1. AGENCY USE ONLY (Leave blank)		2. REPORT DATE 07/00/88		3. REPORT TYPE AND DATES COVERED	
4. TITLE AND SUBTITLE GROUNDWATER INTERCEPT AND TREATMENT SYSTEMS, NORTH OF BASIN F, INTERIM RESPONSE ACTION, ALTERNATIVES ASSESSMENT, FINAL, VERSION 3.1				5. FUNDING NUMBERS

RESPONSES TO COMMENTS OF
SHELL OIL COMPANY ON
DRAFT FINAL GROUNDWATER INTERCEPT AND TREATMENT SYSTEM
NORTH OF BASIN F
INTERIM RESPONSE ACTION ALTERNATIVES ASSESSMENT

FIGURE 4-1
 Generalized Water Table Contours
 Basin F Area
 Rocky Mountain Arsenal
 Prepared by: Ebasco Services Incorporated

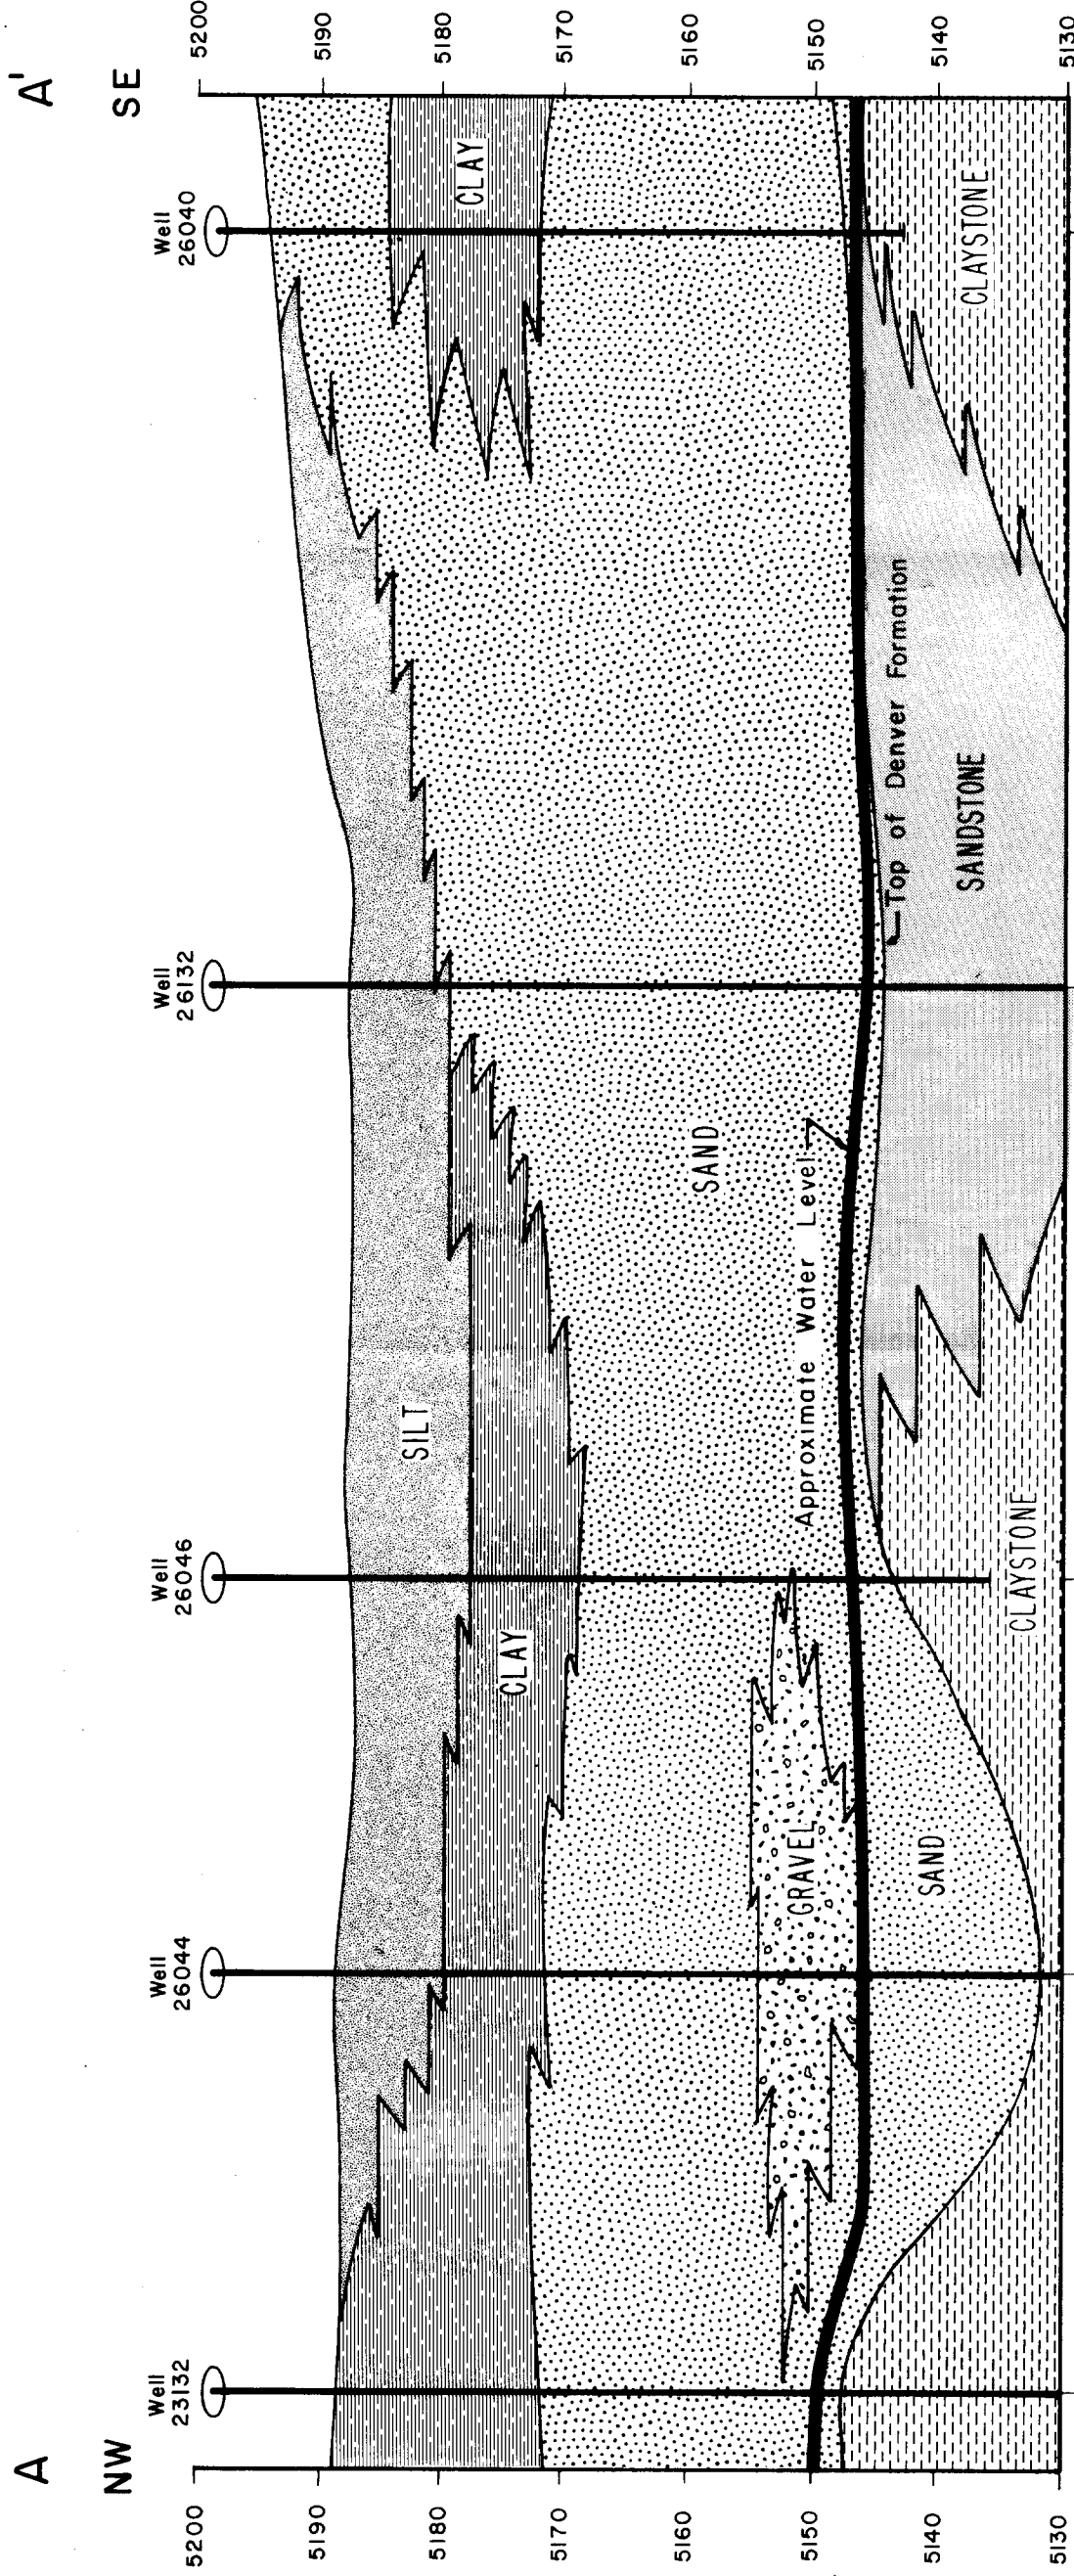
Comment 5: Page 5, Figure 4-1

Reference is made to Figure 4-1 to show preferential contaminant migration pathways due to bedrock valleys and groundwater flow patterns. The discussion should point out the existence of a groundwater divide to the west of Basin F. Therefore, any contamination originating from Basin F would flow predominantly in a north-northeasterly direction where the proposed groundwater control system is to be located.
